Access Compliance Report

Public Rights-of-Way

(Curb Ramps)

Intersection ID: 14547	Main Street: EAST_BV	Cross Street: SPRINGDALE_AV	Location: NE
ADA ID: 447ADD36FDB2	Ramp Type: Directional1	Initial Pass/Fail: Pass	Overall Compliance: No
Codes/Mitigation Info/Possible Solution		Field Measurements/Component Compliance	
Severity Score: 0.25

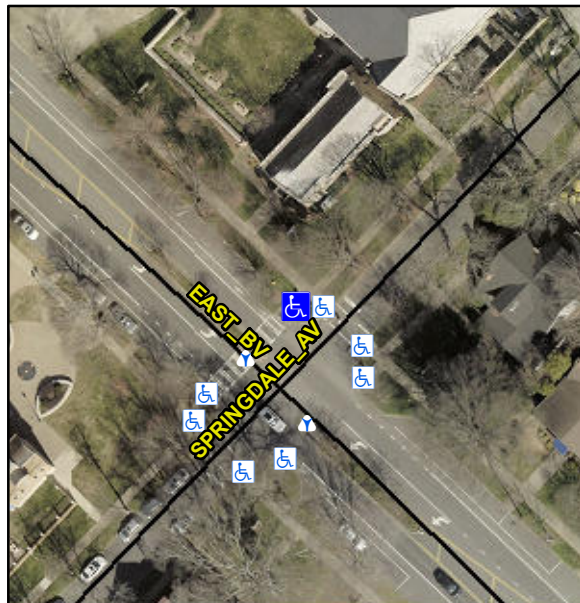
LNDG SLOPE NEGATIVE

**R304.5.3, R304.2.2-Perp, R304.3.2-
Para, R304.5.2**

**Remove & Replace Entire Ramp.
Remove & Replace Gutter.**
